APPROVED DRAWINGS HAVE BEEN RED LINED INDICATING A CHANGE TO MEET THE OBC. PLEASE REVIEW ALL PAGES TO ENSURE YOU ARE PROPERLY INFORMED OF CHANGES.

#### TOWNSHIP OF NORTH DUMFRIES BUILDING DEPARTMENT

These Plans have been examined for Compliance with the Ontario Building Code requirements. A Building Permit has been Issued, subject to any changes noted, under the condition that the building will be constructed in accordance with the code.

client  
Tice River Homes  
project  
Legacy

A0

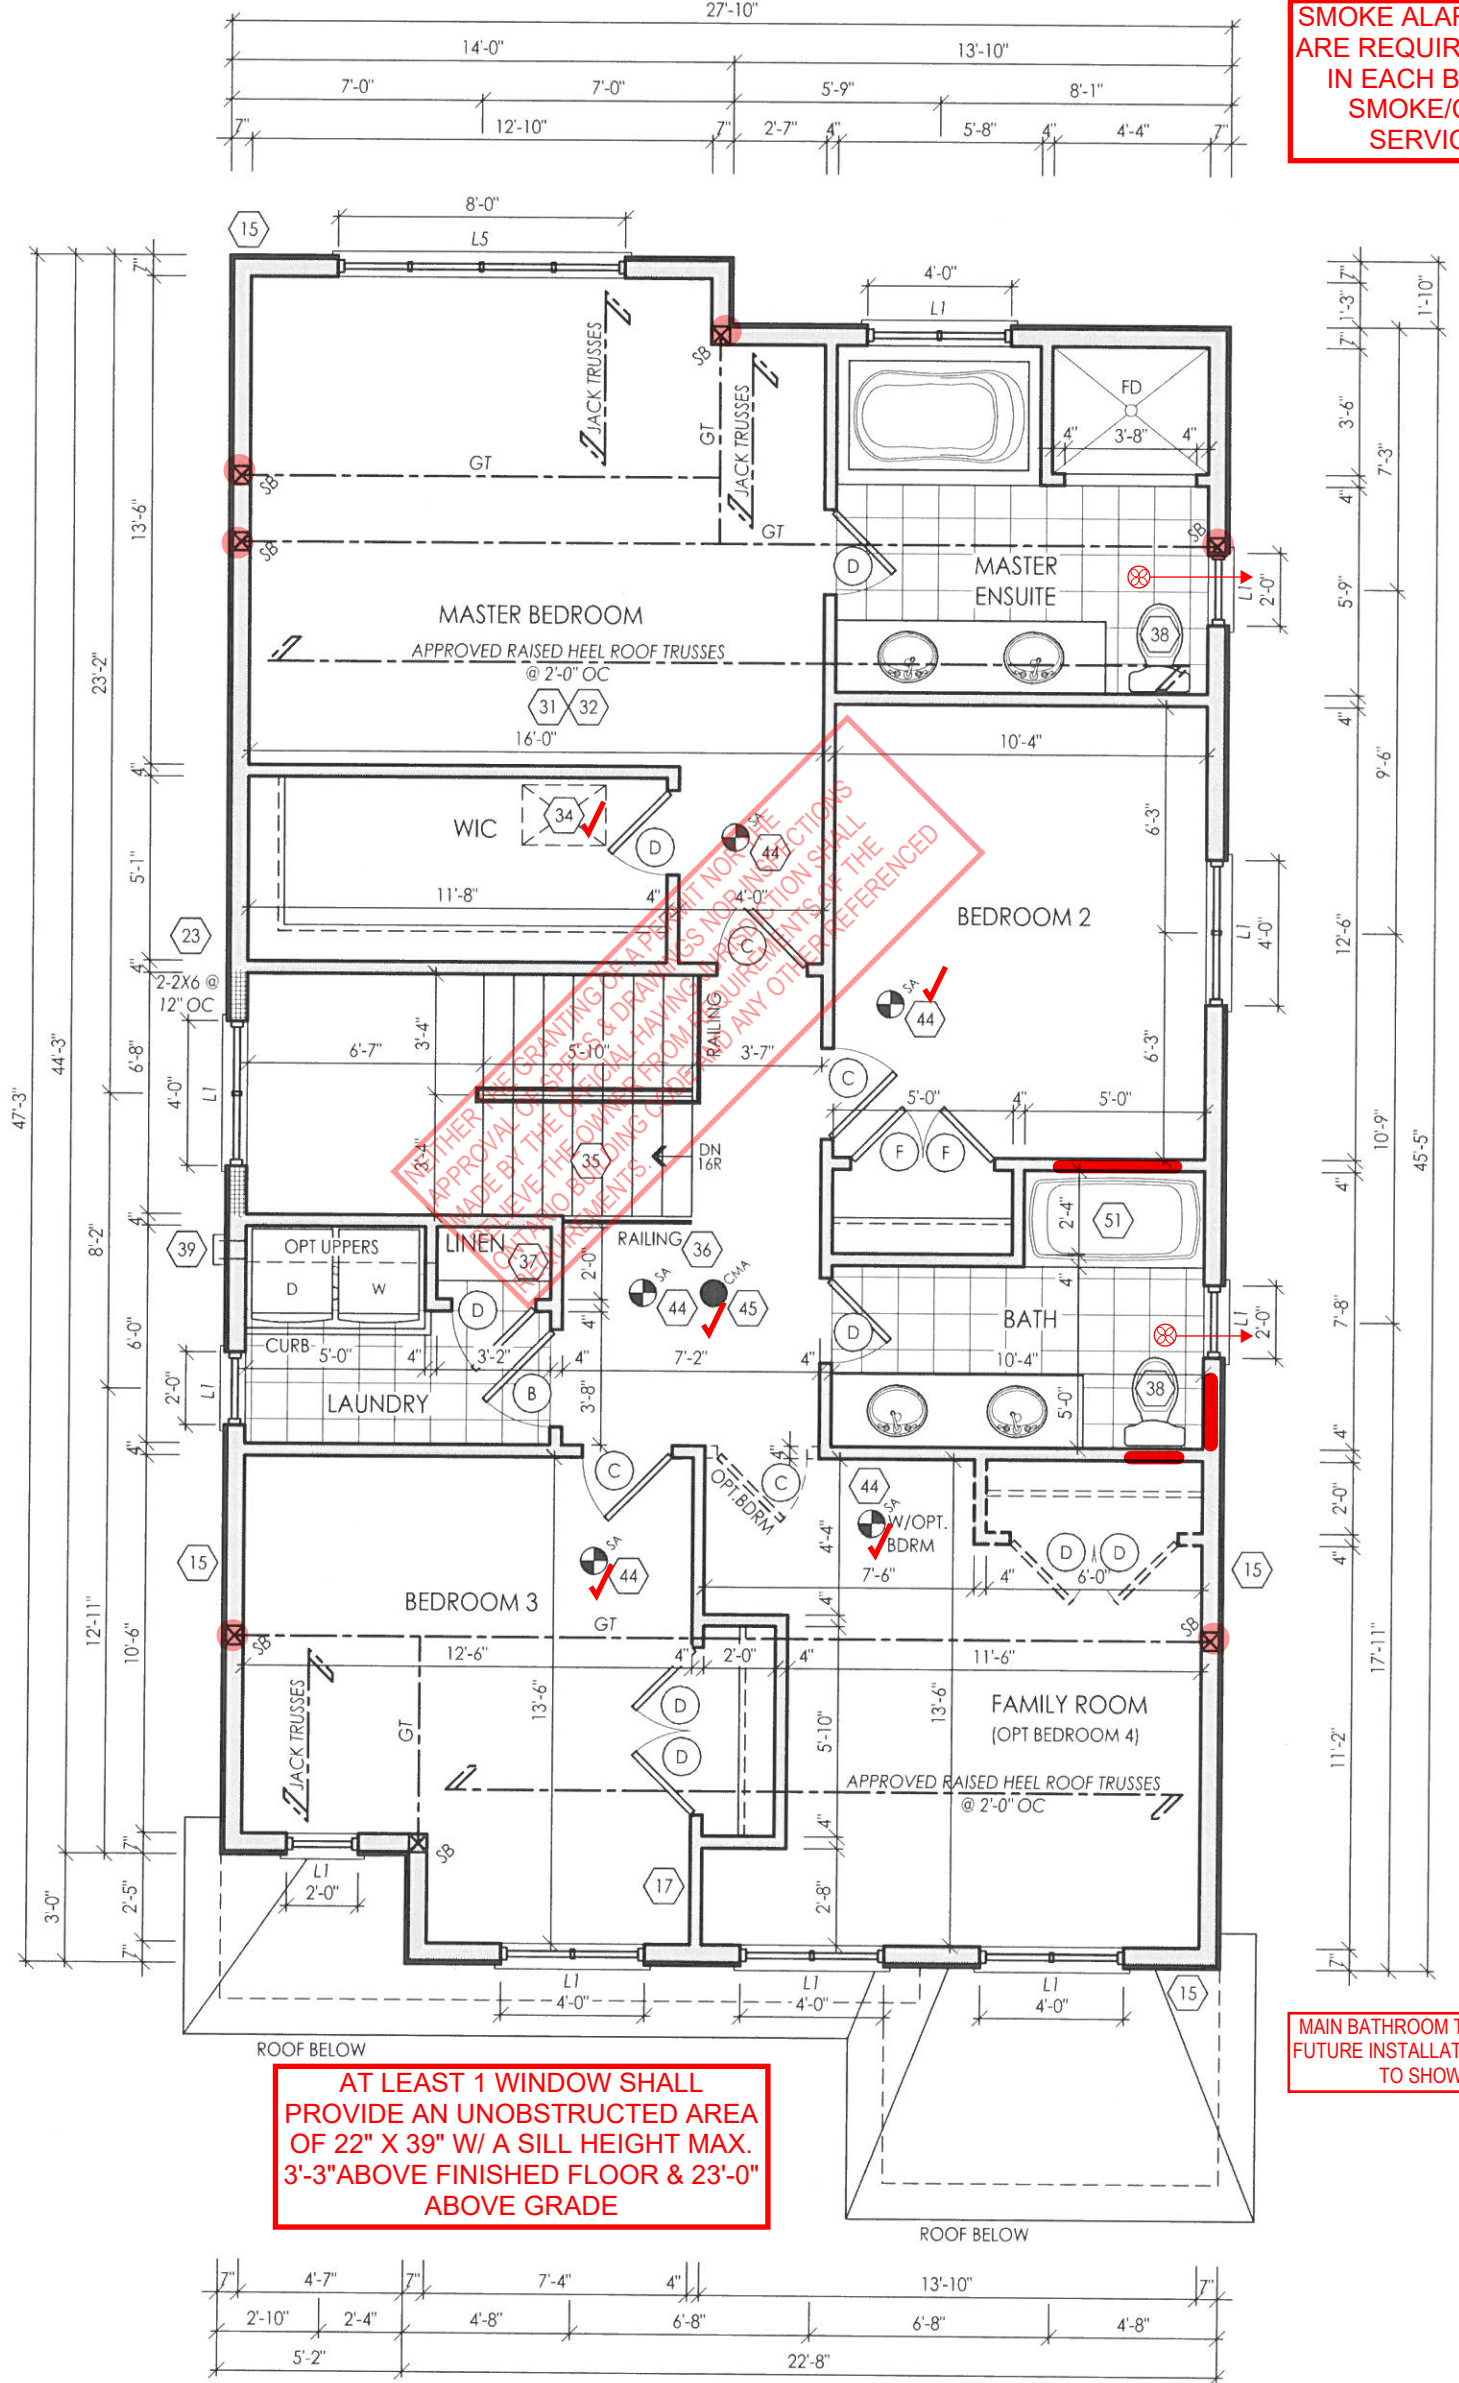
CALL FOR INSPECTION OF EXCAVATION CRIBBING BEFORE POURING ANY CONCRETE

FINAL GRADING CERTIFICATE REQUIRED BEFORE FINAL INSPECTION SIGN-OFF

**SECOND FLOOR ELEV. 'A'**

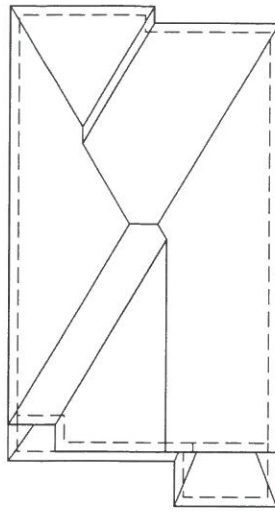
**SMOKE ALARMS WITH VISUAL ALARM ARE REQUIRED ON EACH FLOOR AND IN EACH BEDROOM INCLUDING A SMOKE/CO IN THE HALL THAT SERVICES THE BEDROOM.**

**AT LEAST 1 WINDOW SHALL PROVIDE AN UNOBSTRUCTED AREA OF 22" X 39" W/ A SILL HEIGHT MAX. 3'-3" ABOVE FINISHED FLOOR & 23'-0" ABOVE GRADE**

**MAIN BATHROOM TO HAVE STUD BLOCKING FOR FUTURE INSTALLATION OF GRAB BARS ADJACENT TO SHOWER/TUB AND TOILET.**
